Amendments to the Drawings:

<u>REMARKS</u>

Fig. 1

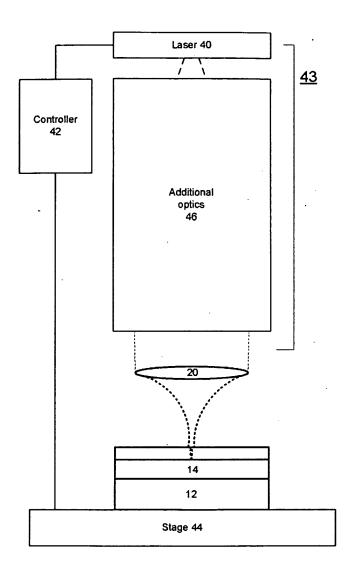
In Figure 1, the top view of the spot formed by the laser beam (which the examiner indicated was

confusing) has been eliminated, as has the reference to interface 22, which was not include din

the specification.
